Lime Down

Solar Park

Outline Construction Traffic Management Plan (Tracked)

Revision 67

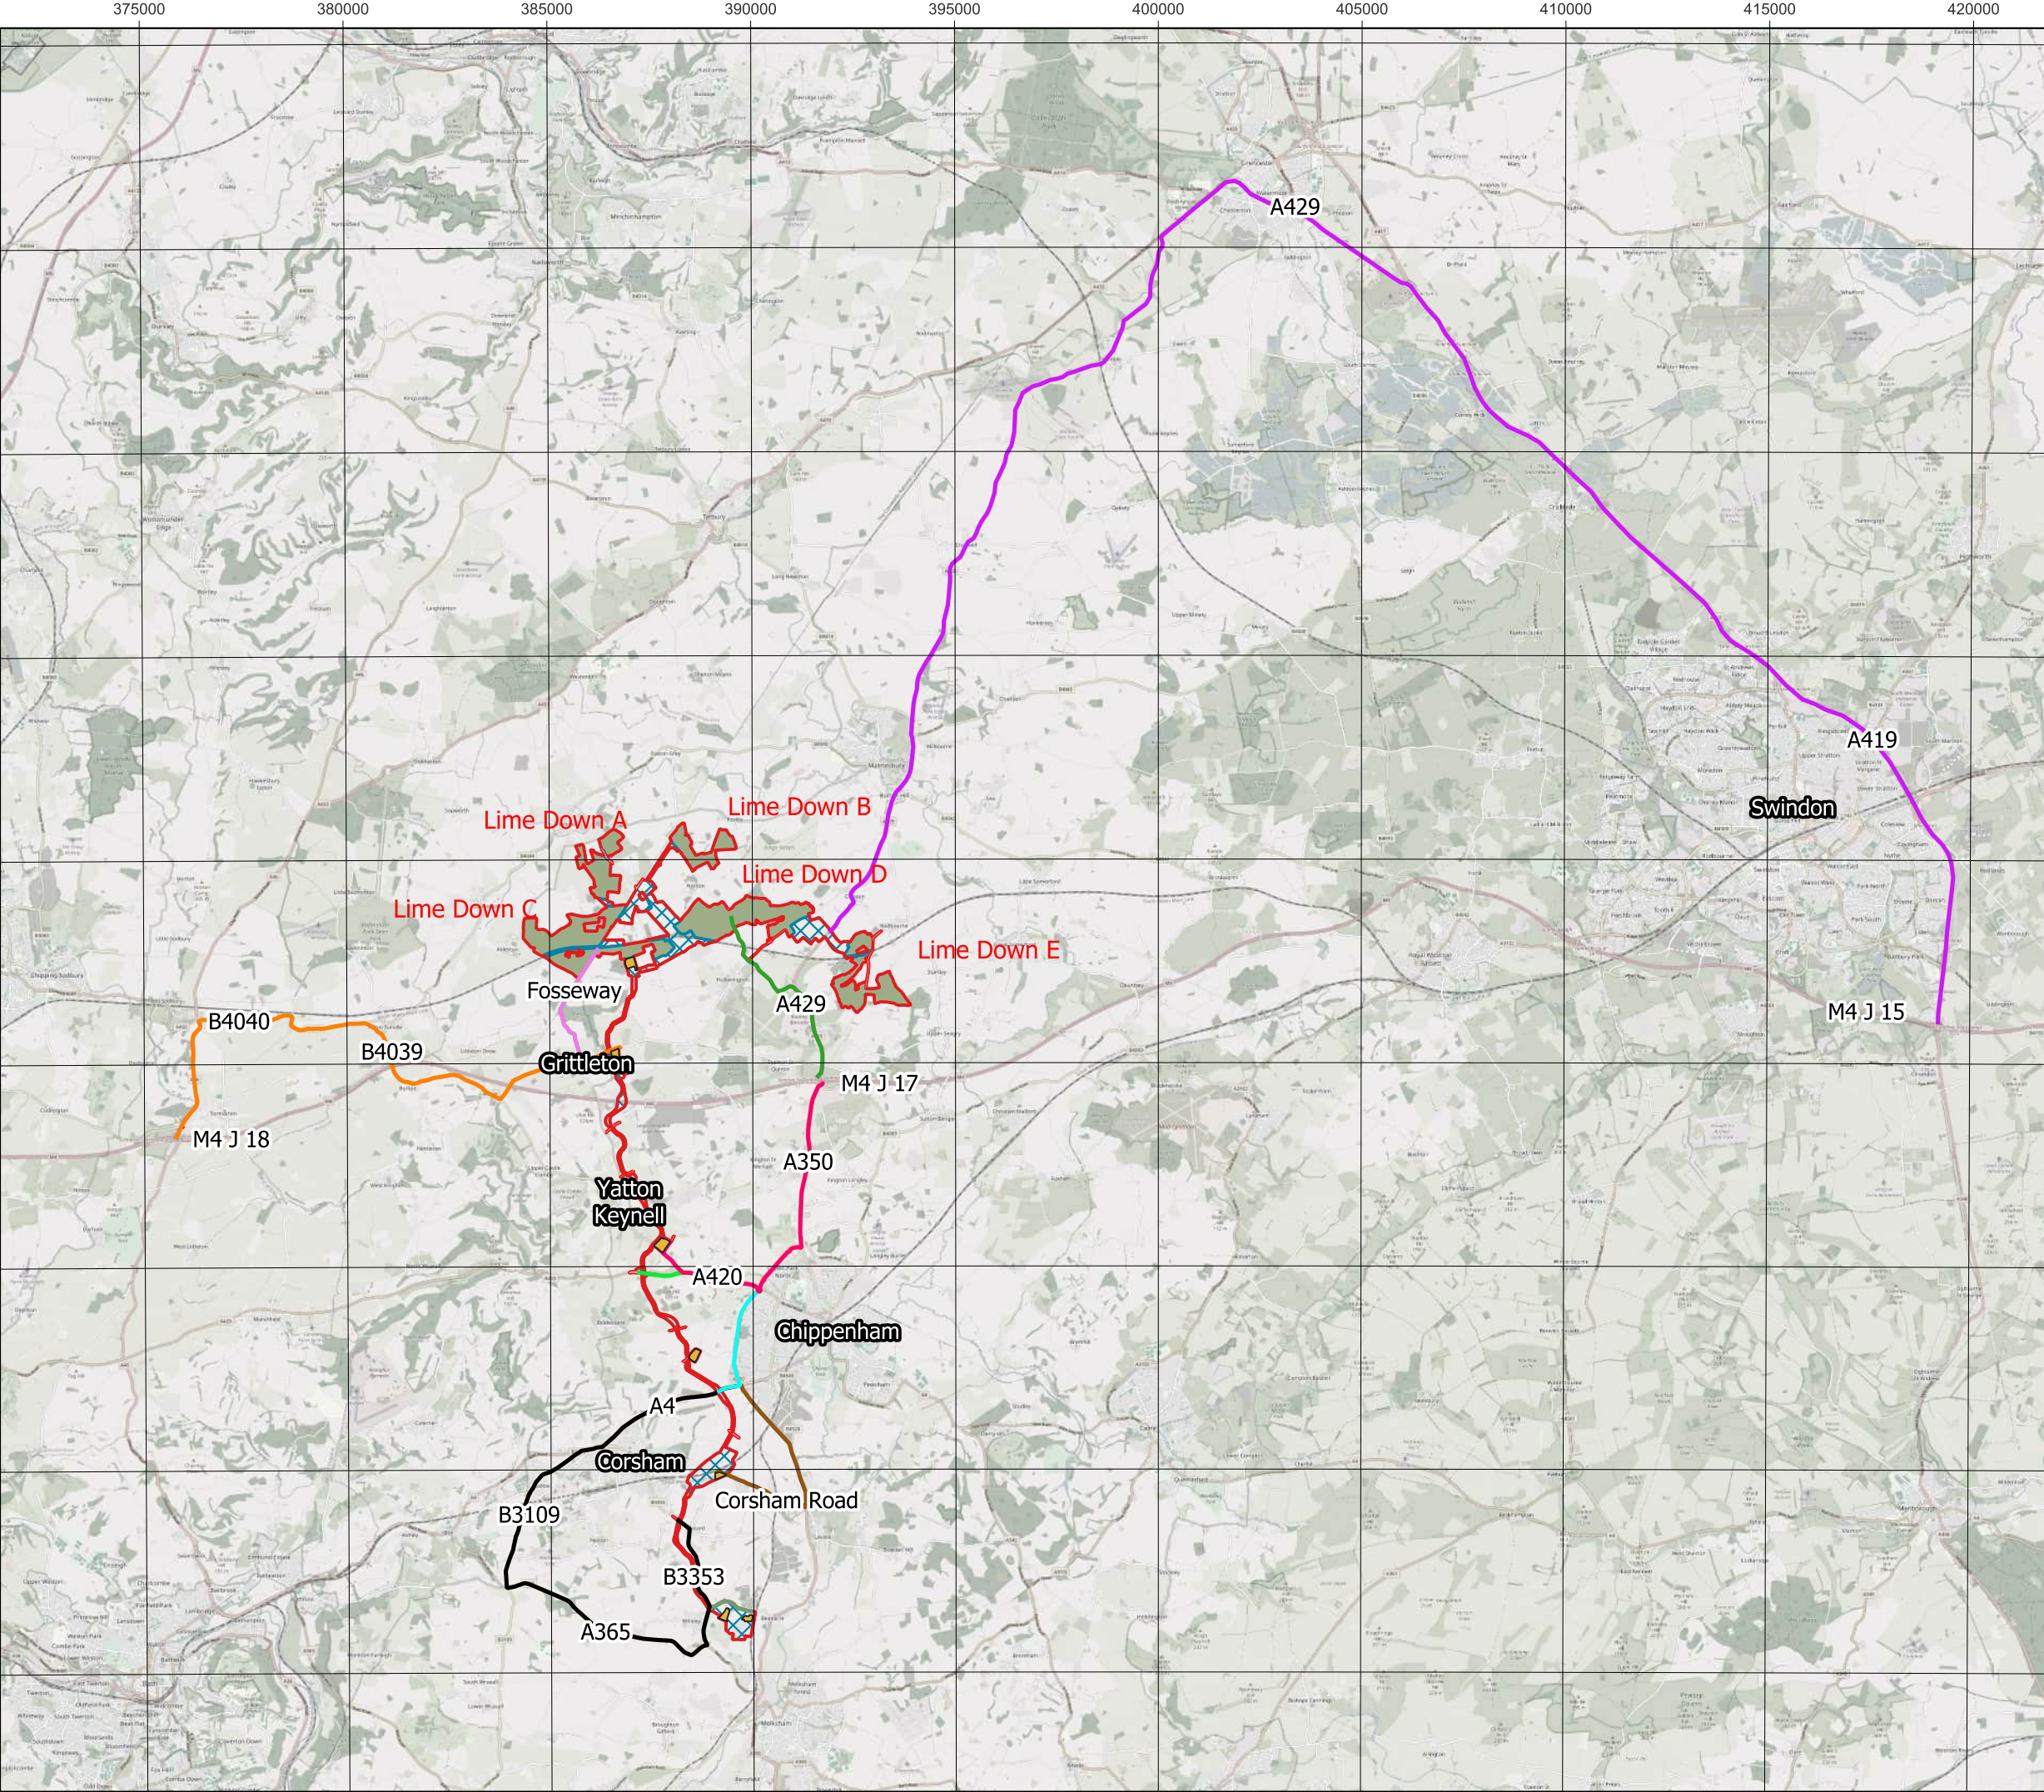
Figure 5.2	Figure added to show AIL routes to Cable Route Corridor	Included for Deadline 1 of Examination following hearings
	Table 8, Appendix D	Updated to provide breakdown of abnormal load movements for eastern and western construction routes to Lime Down D	Updated for Deadline 1 of Examination in response to Wiltshire Council's Relevant Representation.
